Proposal for amendments regarding ECE/TRANS/WP.29/2022/59

Modifications to ECE/TRANS/WP.29/2022/59 are in **bold** for new or ~~struck through~~ for deleted characters.

Model A

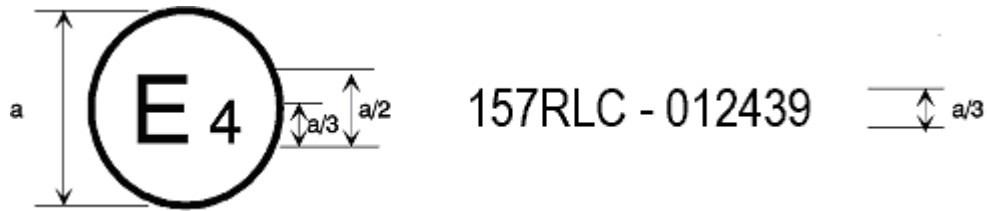
The above approval mark affixed to a vehicle shows that the vehicle type concerned has, with regard to ALKS, been approved in the Netherlands (E 4) pursuant to UN Regulation No. 157 under approval No. ~~002439~~ **012439 and is capable of a lane change procedure**. The approval number indicates that the approval was granted in accordance with the requirements of UN Regulation No. 157 ~~in its original version~~ **with the 01 series of amendments incorporated**.

Model B

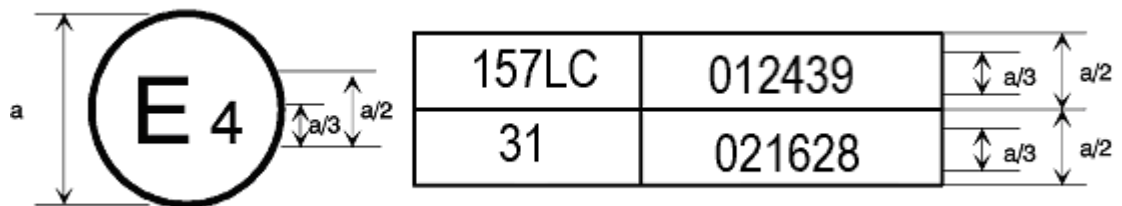
The above approval mark affixed to a vehicle shows that the vehicle type concerned has been approved in the Netherlands (E 4) pursuant to Regulations Nos. 157 (**capable of a lane change procedure**) and 31.¹ The approval numbers indicate that, at the dates when the respective approvals were given, UN Regulation No. 157 ~~was in its original version~~ **included the 01 series of amendments** and UN Regulation No. 31 included the 02 series of amendments.

2. Modification to the provision for the approval mark to indicate systems that are capable of performing an LCP by adding paragraph 4.4.3.and modifying Annex 2.
